MASTER-LEE ENGINEERED PRODUCTS INC.

P
E
N
C
I
L
I
T
E

*Change in part number & design for the Master-Lee Engineered Products
PenciLite Globe.*

New Globe Design

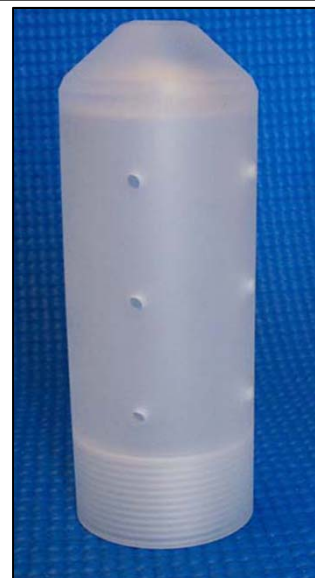
In our continuing efforts to improve our products and meet our customer's needs, we have changed the design of the **PenciLite** Globe.

The new globe is a direct replacement – in material, form, fit, and function – to the original style (OEM) The new globe (Part Number C1954) will replace the old design (Part Number D0012G01) as an included part of the **PenciLite** assembly.

The change was done to decrease the possibility of a loss of material event and alleviate the extra efforts taken by some customers to address this concern.

The globe is now a one-piece design. This design prevents the possible separation of the two parts that made up the original design.

New Part Number: C1954

New Globe Design

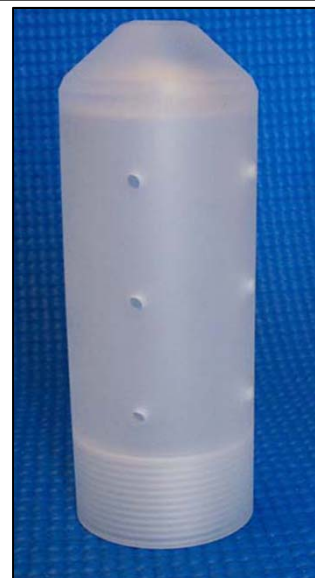
In our continuing efforts to improve our products and meet our customer's needs, we have changed the design of the **PenciLite** Globe.

The new globe is a direct replacement – in material, form, fit, and function – to the original style (OEM) The new globe (Part Number C1954) will replace the old design (Part Number D0012G01) as an included part of the **PenciLite** assembly.

The change was done to decrease the possibility of a loss of material event and alleviate the extra efforts taken by some customers to address this concern.

The globe is now a one-piece design. This design prevents the possible separation of the two parts that made up the original design.

New Part Number: C1954
